City Of Wichita Lift Station 56 Improvements 468-2024-031960 ORG 53200222 S2013

MECHANICAL
WETWELL, VALVE VAULT AND METER
VAULT - PLAN AND SECTION

CADFILE: m18253m51
DATE: 11-13-01
OPERATOR: TBreder
DRAWING NO.
M101
SHEET NUMBER
52 OF 79

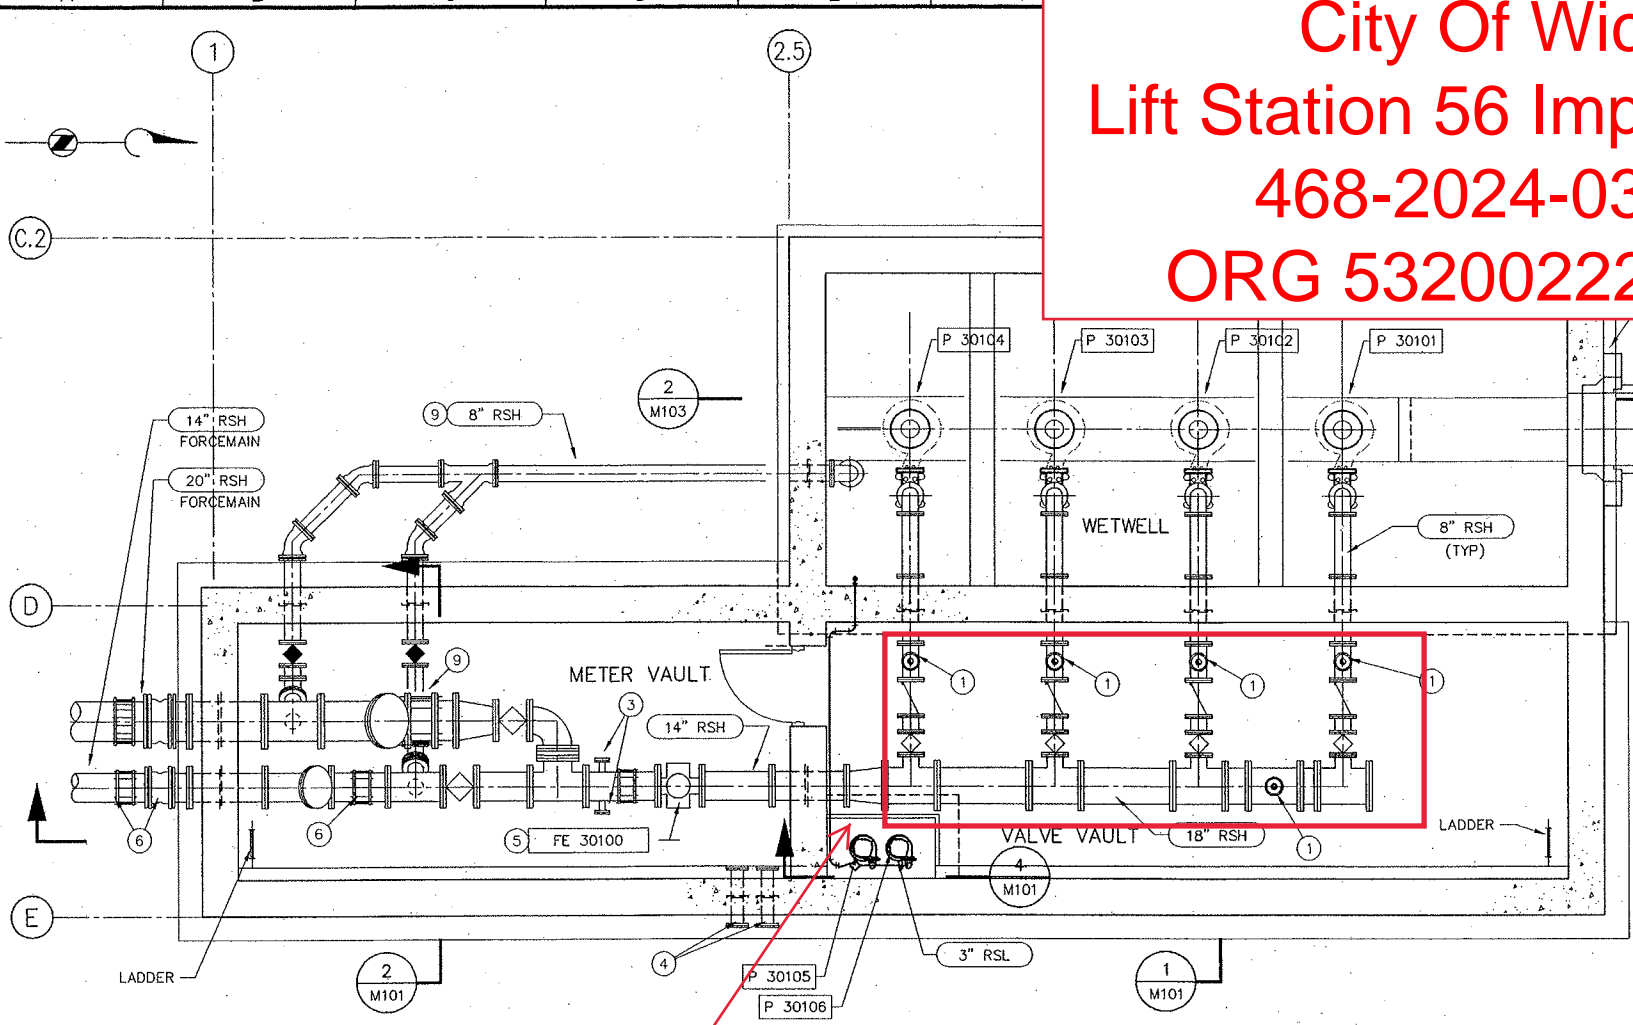
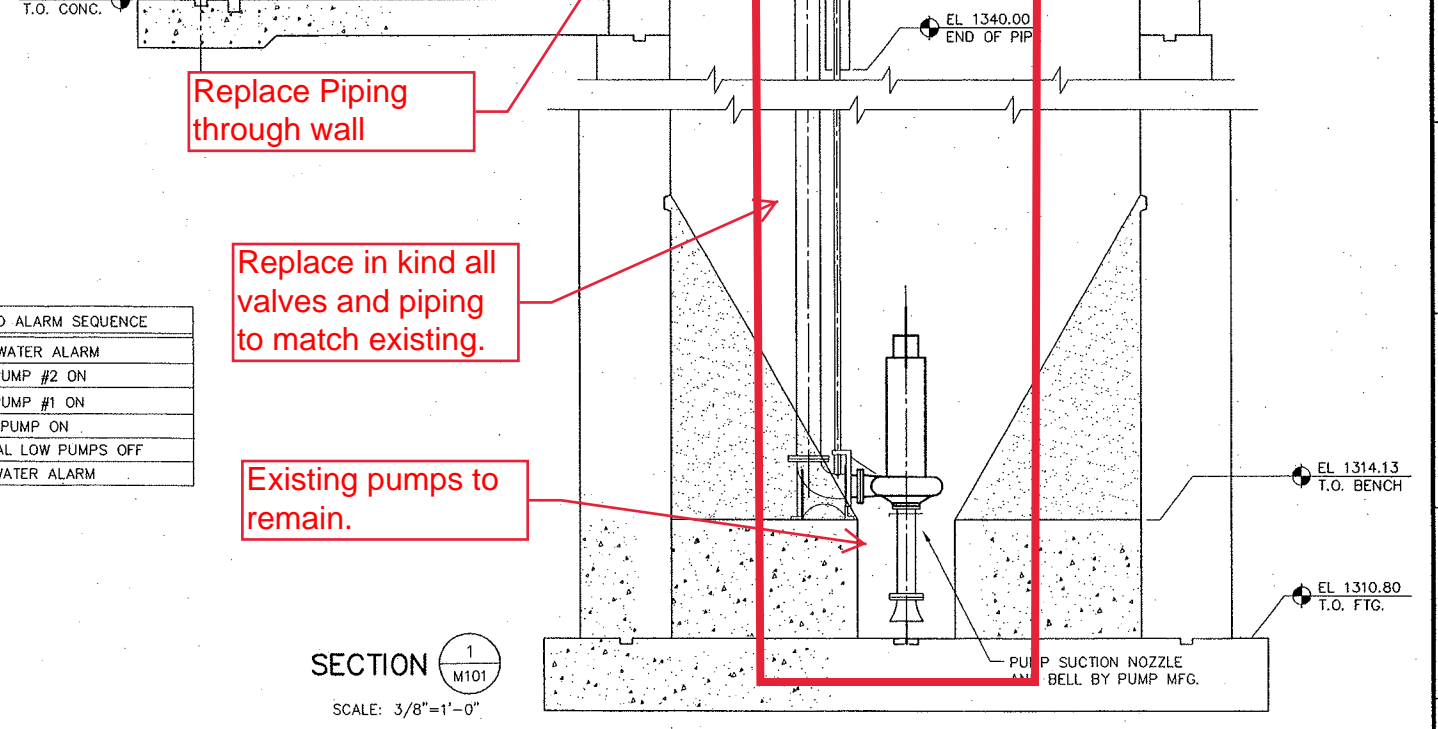
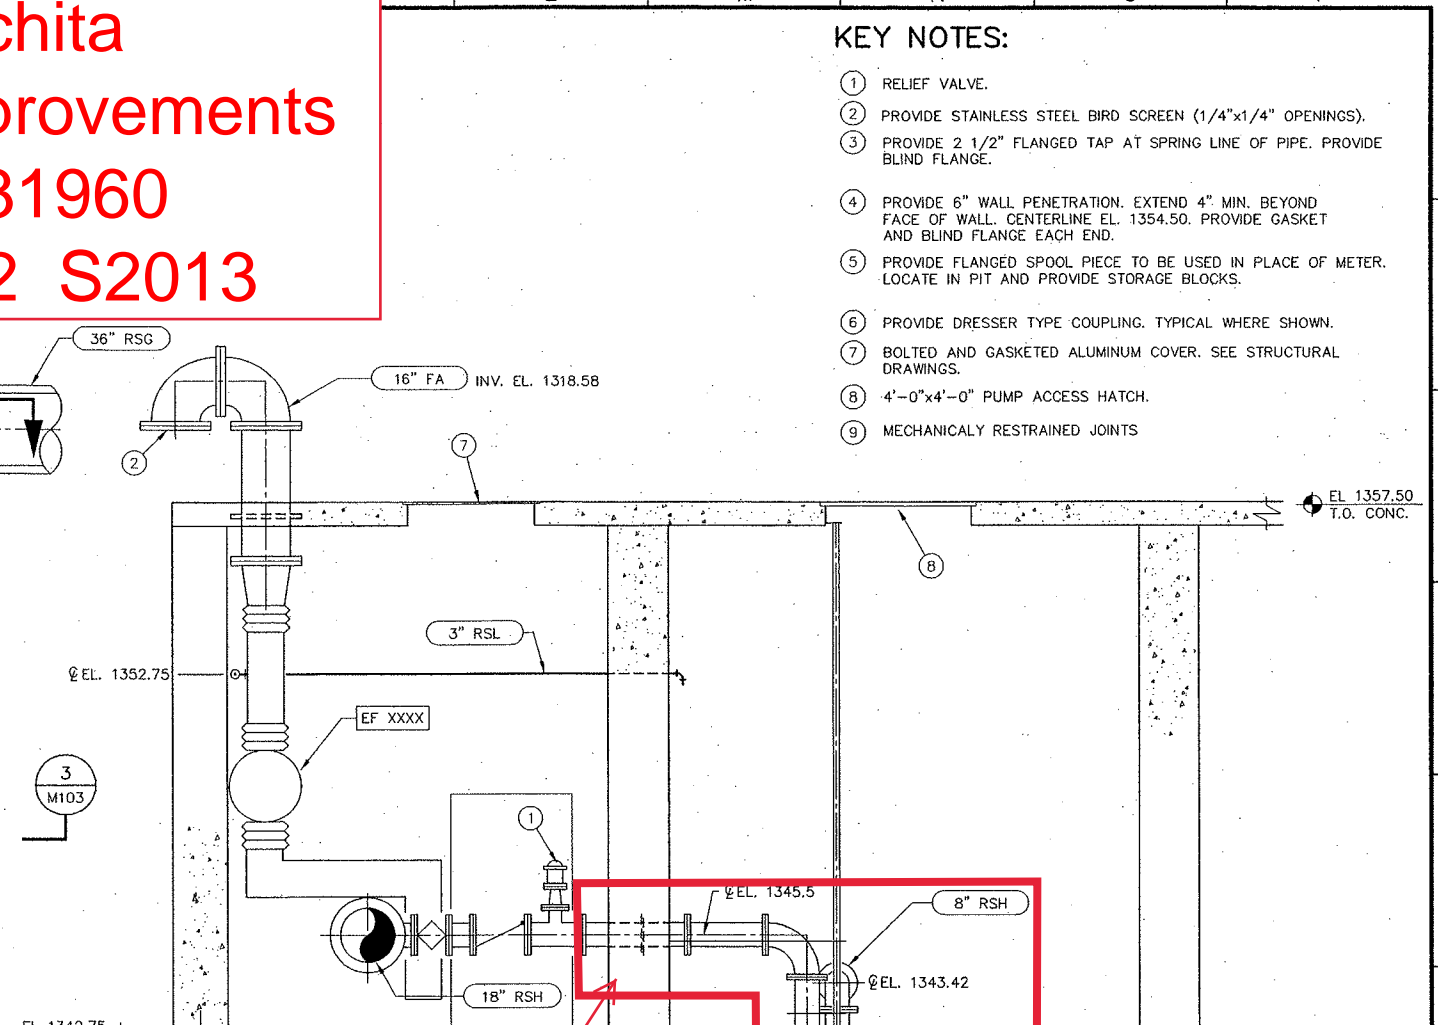
Replace in kind all valves and piping up to the existing reducer.

Replace Piping through wall

Replace in kind all valves and piping to match existing.

Existing pumps to remain.
